Re: Site Plan Submission
Parkside Bible Church Addition
491 Eastern Boulevard

Attached to this email submission dated 01/29/2013 please find the pdf file of the revised Parkside Bible Church site plans. Hardcopies will be delivered by the morning of 01/31/2013.

New Expansion Project Parkside Bible Church

ISSUE DATE: 01/28/13 (Rev.-5)

DRAWING NO.
C104
SITE LANDSCAPING PLAN

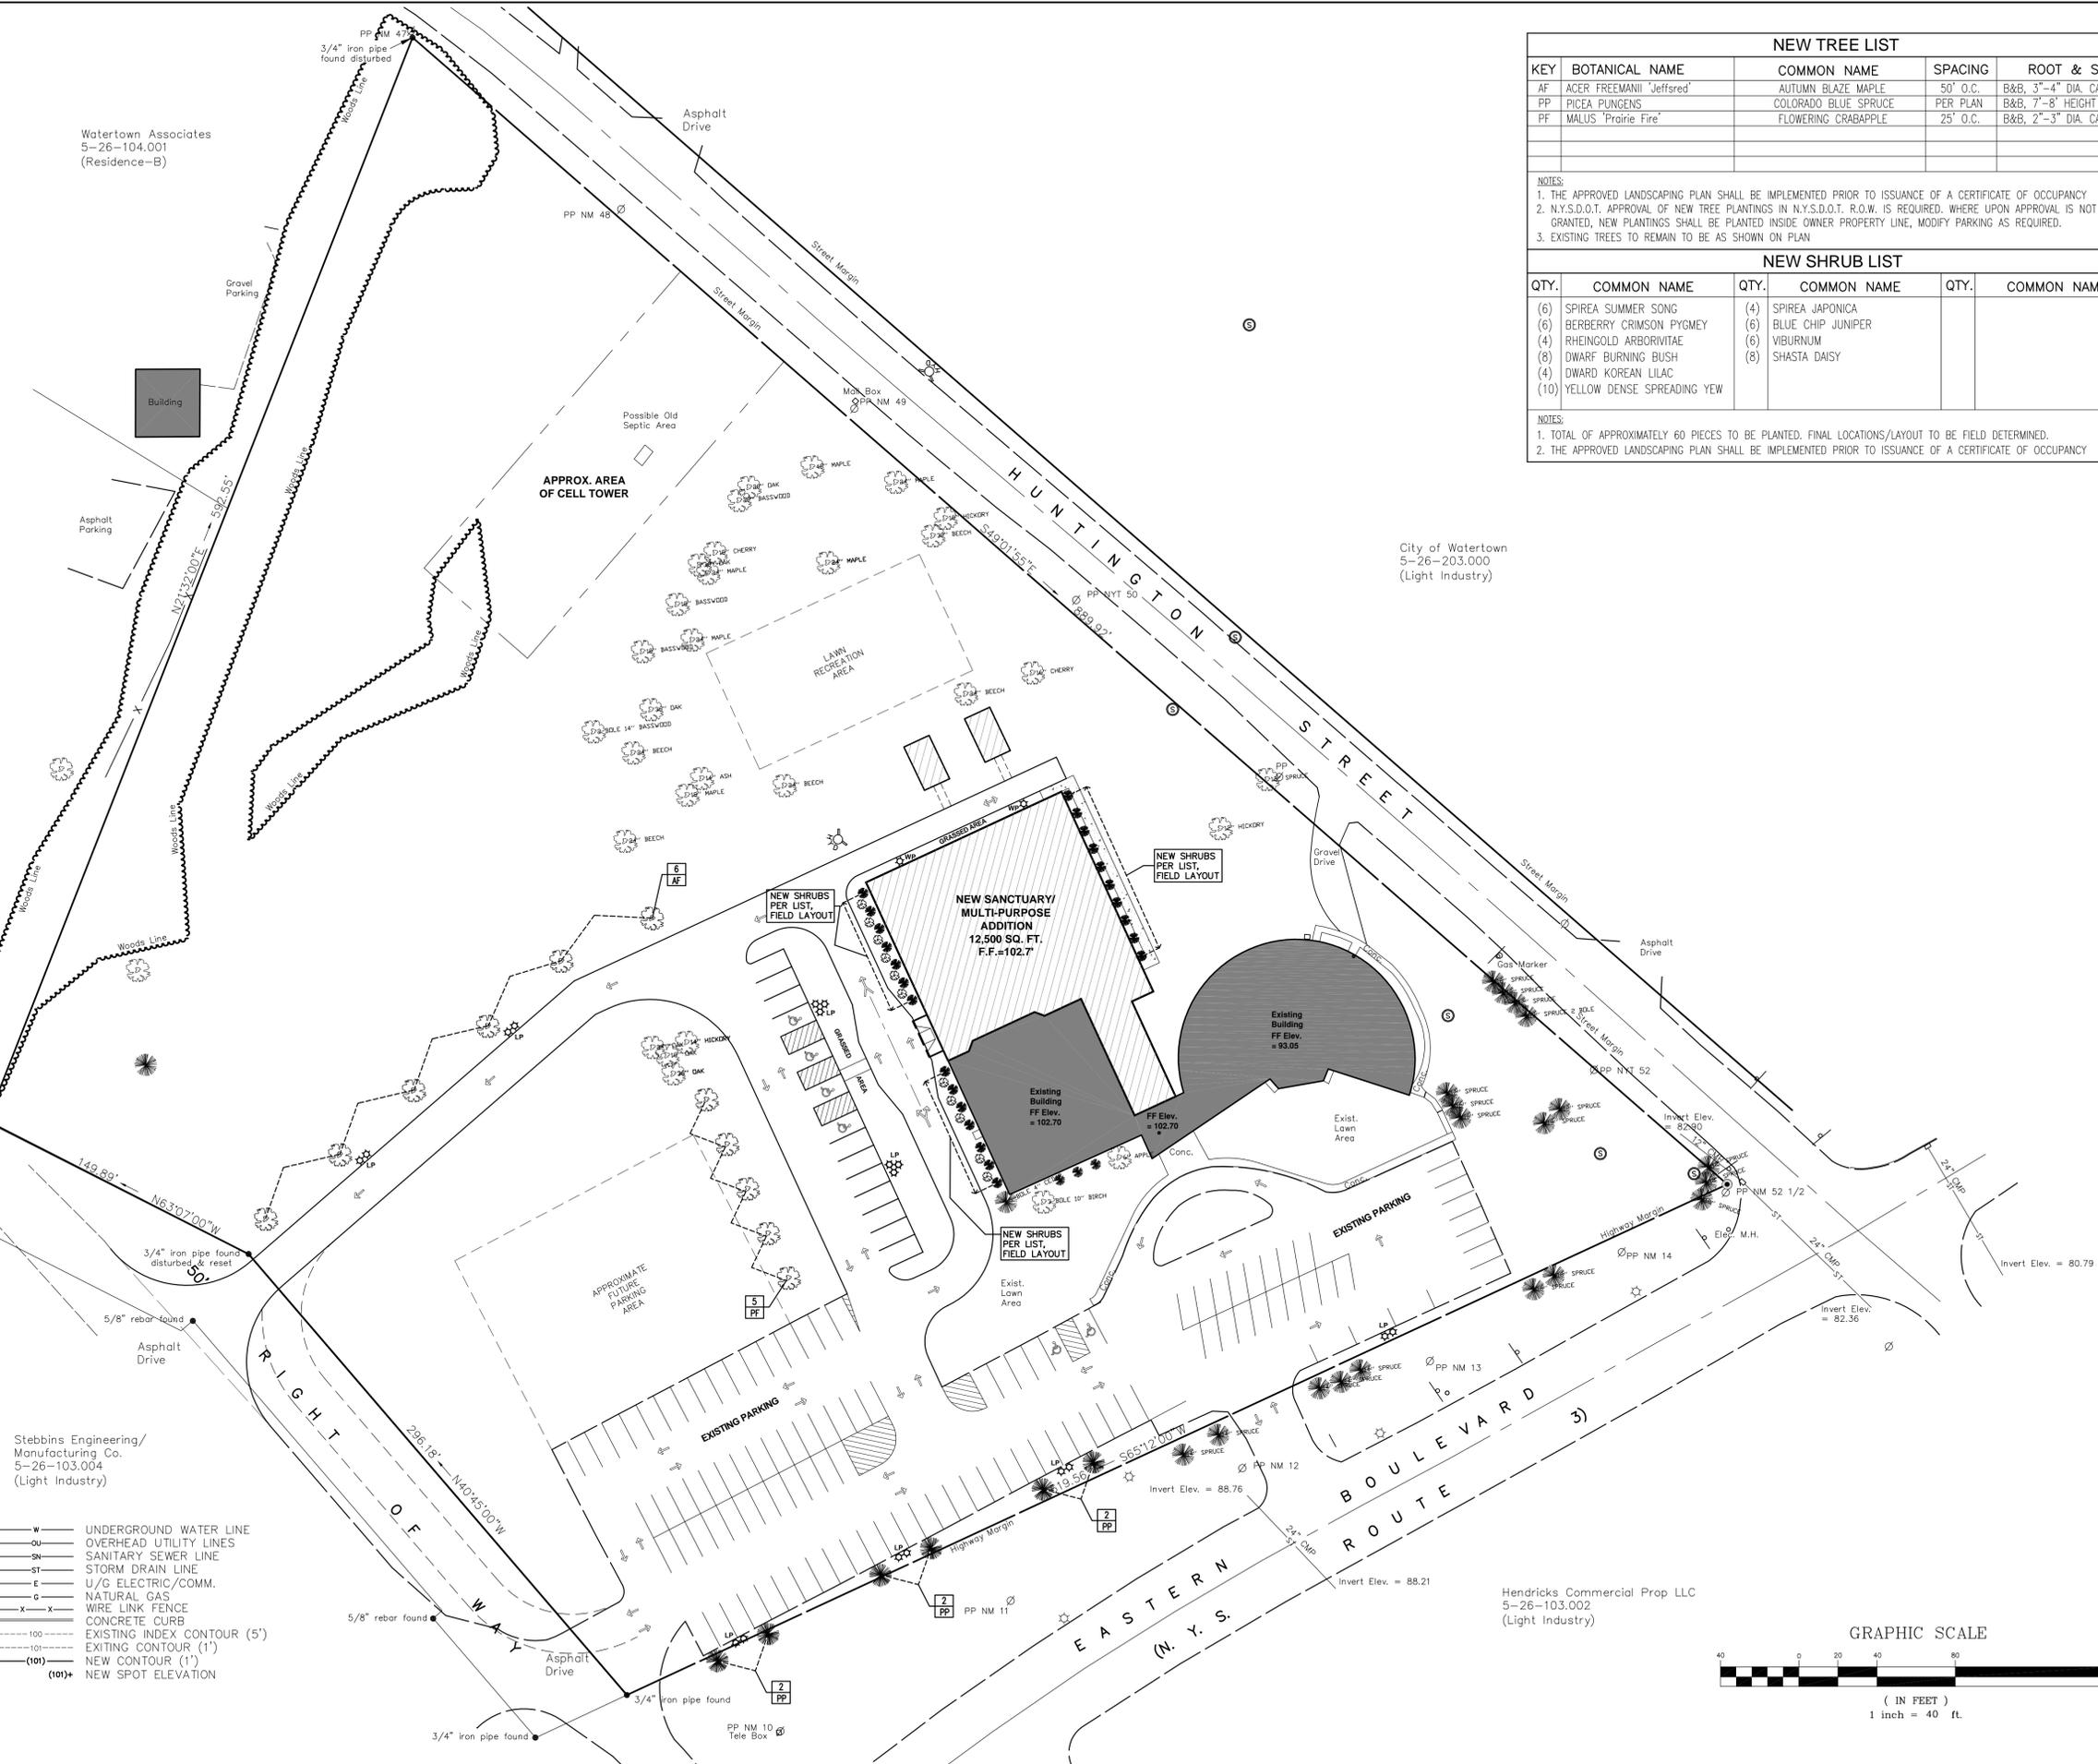
7. The applicant shall provide a complete landscaping plan and landscaping schedule, that includes a depiction of the quantity, species, and size of the proposed tree removals overlaid on the site plan—and a planting plan that includes new trees along the exterior (perimeter) of the existing and proposed lot parking lots and buildings, trees in the interior of the parking lot (islands), and trees along the Huntington Street right-of-way.

8. The approved landscaping plan shall be implemented prior to issuance of a Certificate of Occupancy.

A revised landscaping plan has been provided on C104.

The approved landscaping will be accomplished prior to issuance of a Certificate of Occupancy, as noted on C104.
